In the Drawings:

REMARKS

Fig. 1

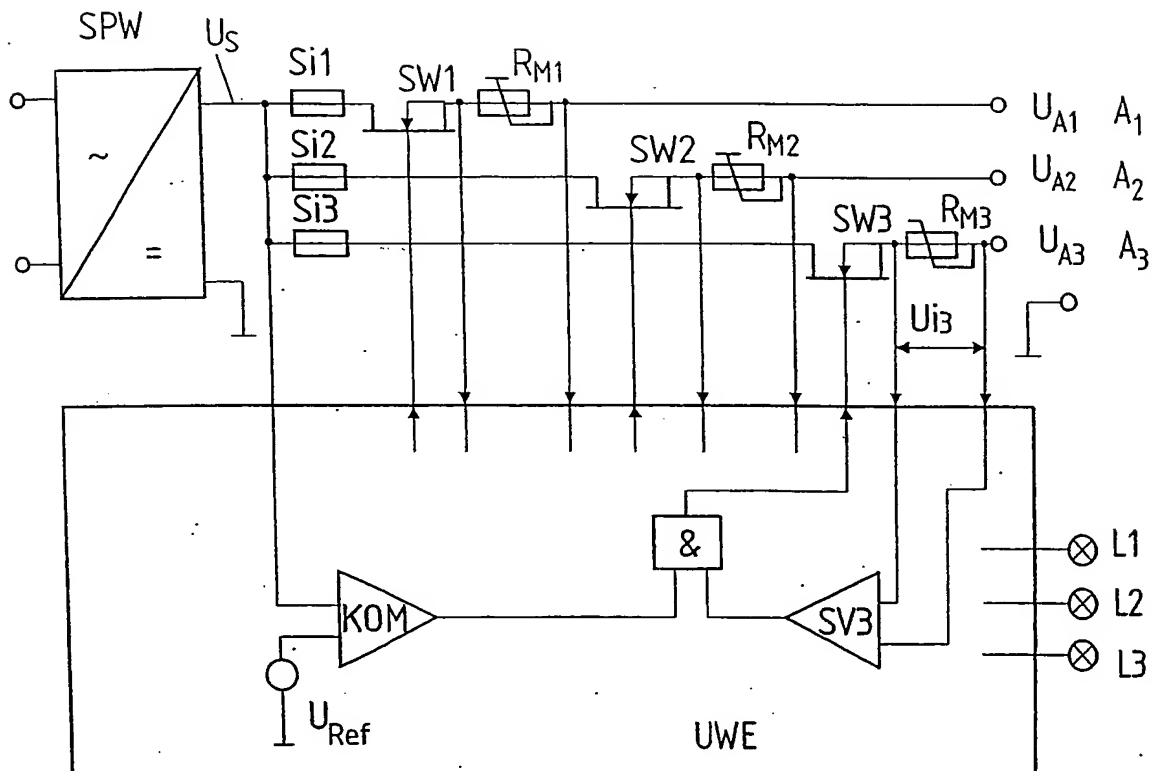
Please amend the drawings as shown in the attached marked up copy thereof and in the enclosed Replacement Sheets thereof. For Figure 1 on the first sheet of drawings, and for Figures 2 and 3 on the second sheet of drawings, there have been added respective Tables that identify all of the components that have reference letters and numbers on the circuit diagram, with identifying text for two components actually placed on the circuit diagrams of Figures 2 and 3.

ADDED

Fig. 2

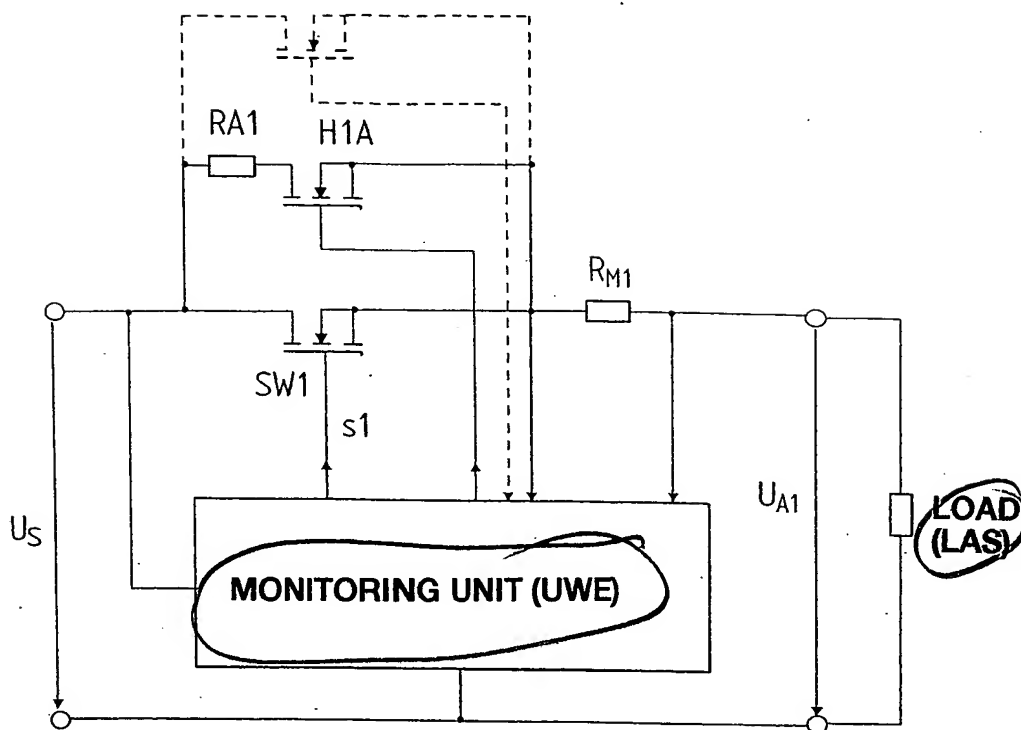
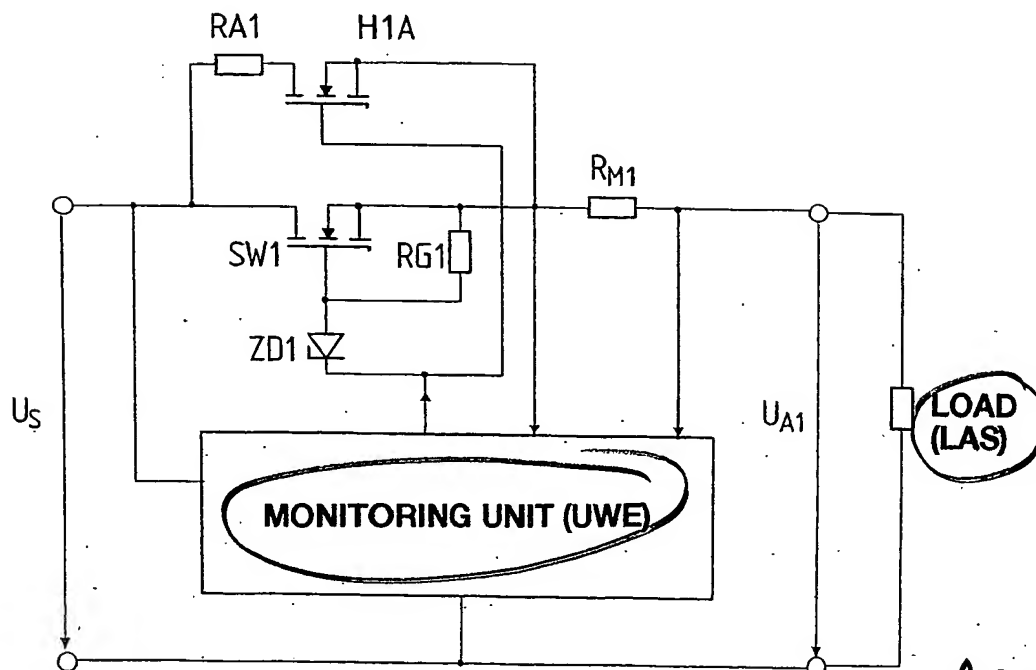
ADDED
